SERVICE POLICY LETTER

Reference number:	SPL-03-1088	Issued: 21 August 2018
Subject:	Introduction of a Remanufactured Long-Block V8 Engine	
Applicable to:	All Dealers (Not China)	
Distribute to:	After Sales Manager Executive Manager Service Manager Sales Manager	Warranty Staff Technician(s) Parts Staff

Figure 1

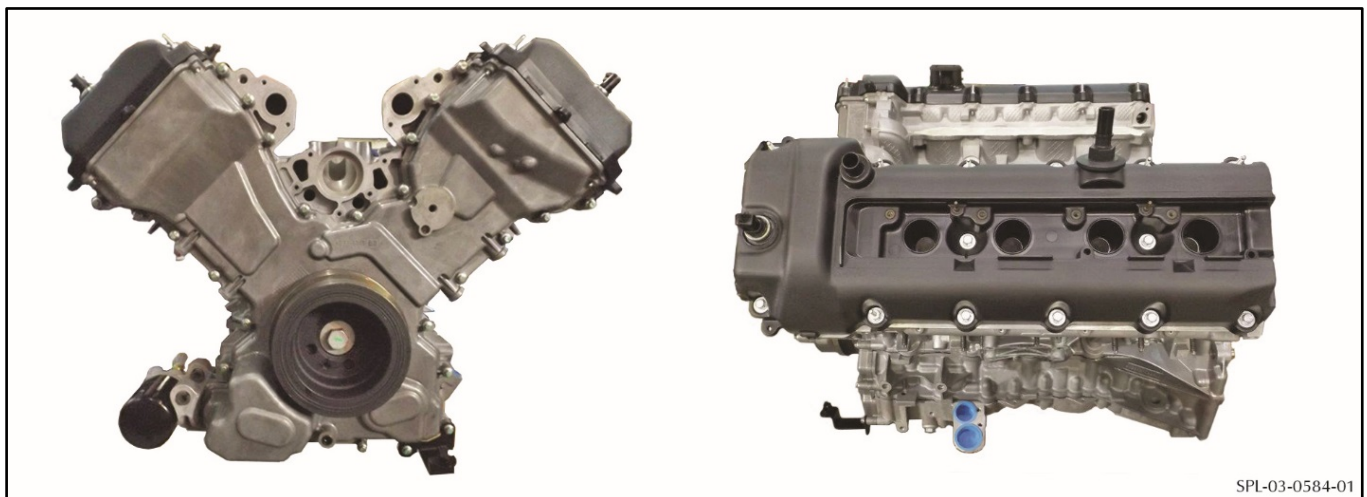
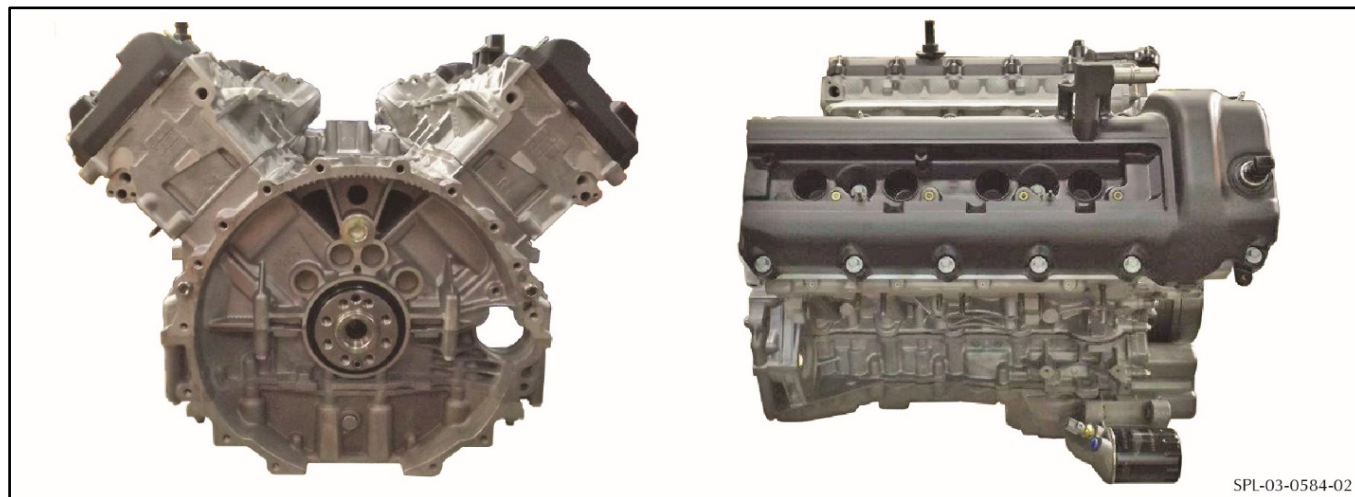
Figure 1 and Figure 2 show an engine in the correct condition to return to be reconditioned. Make sure that all components that follow are removed:

- Flywheel
- Starter motor assembly and bracket
- Alternator assembly and bracket
- Water pump assembly and thermostat
- Inlet manifold assembly
- Secondary air pump and related pipes
- Power steering pump assembly
- Wiring harness
- Ignition coils
- Accessory drive belt and tensioners
- Lifting eyes
- All brackets, hoses and pipes.

Note: *Do not remove the spark plugs. They will give protection against contamination during transport. Always install new spark plugs in the remanufactured engine.*

You will need to install all of these components onto the replacement long-block engine before and during installation. Install all of the plastic sealing plugs that you remove from the remanufactured engine into the old engine for return.
